Public Comments:

A Structural Reevaluation of the Collapse of World Trade Center 7 – Draft Report

Hulsey, J.L., Quan, Z., and Xiao, F.

Department of Civil and Environmental Engineering, College of Engineering and Mines, Institute of Northern Engineering, University of Alaska Fairbanks, Fairbanks, AK
INE Report 18.17

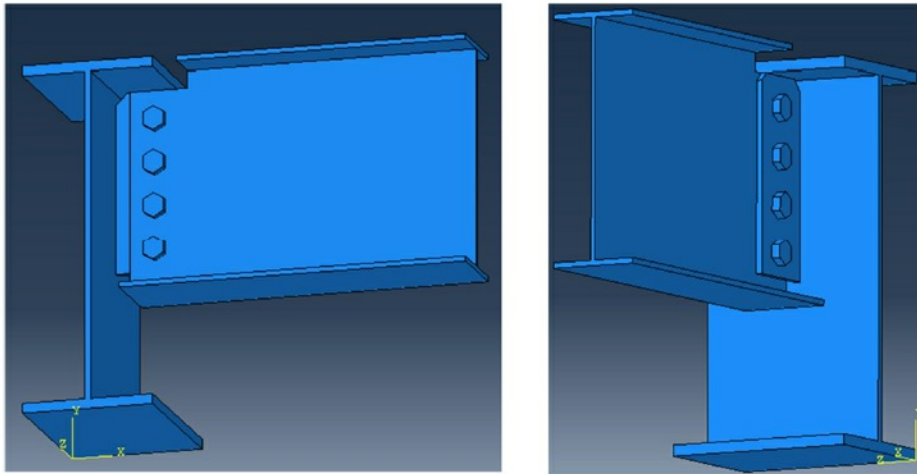
(3) page 55 - reference to Figures 2.39 and 2.40 omitted, unnumbered figures appear duplicated

Figure 2.5 Progressive collapse separated into two parts.

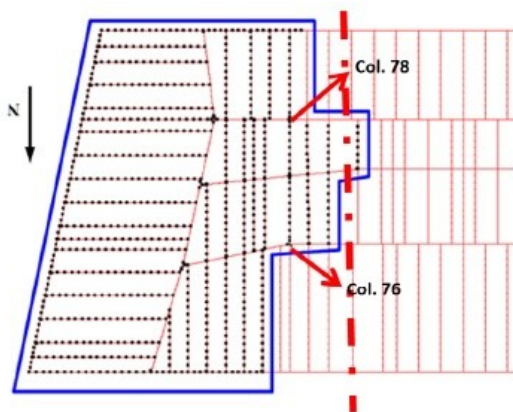
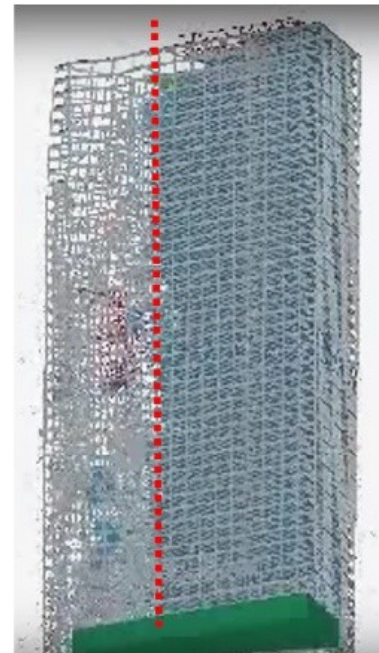
Figure 2.5 juxtaposes two different models:

The floor connections east and west are modeled differently only in the ANSYS model (left), not in the LS-DYNA model (right)! It seems reasonable that, in the right image, the east part looks less

Figure 4.23: Velocity comparison between Chandler measurement (green plotted line) and UAF simulation (red plotted line). Bold green trend line illustrates free fall.

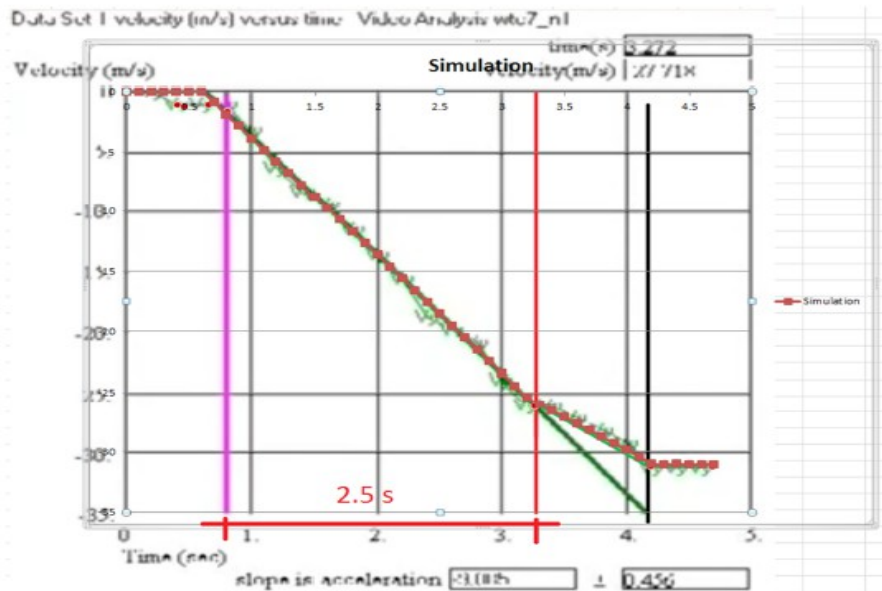
Moreover the UAF report says: “Bold green trend line illustrates free fall”.

This is not accurate. Bold green trend line illustrates a free fall in the vacuum, so it is not realistic. Falling speed of WTC7 reached a velocity greater than 30m/s. At such speed it is not correct to ignore the presence of air, so velocity vs. time should not be linear. Free fall in the air must take into account a resistant force depending on the speed and which increases with speed. As a consequence, in a real free fall, velocity must tend asymptotically to the limit velocity v_L according to the following picture.

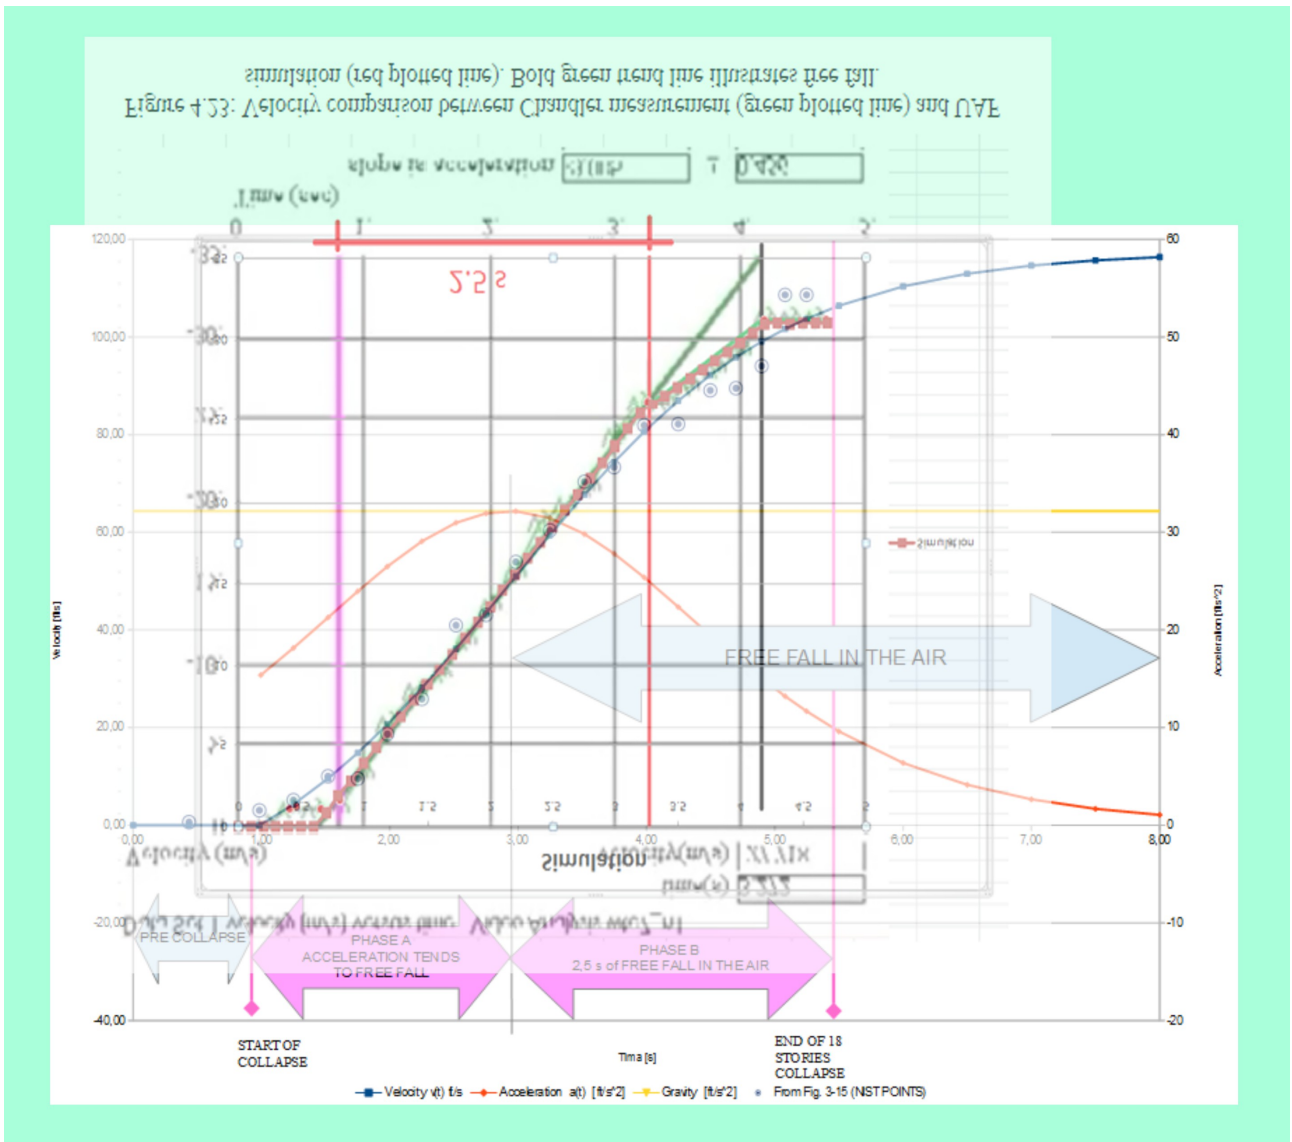
In the following there is an overlap between presious figure and UAF report Fig.4.23:

As you can see the function which interpolate NIST data set is extremely similar to both UAF simulation and David Chandler measurement.
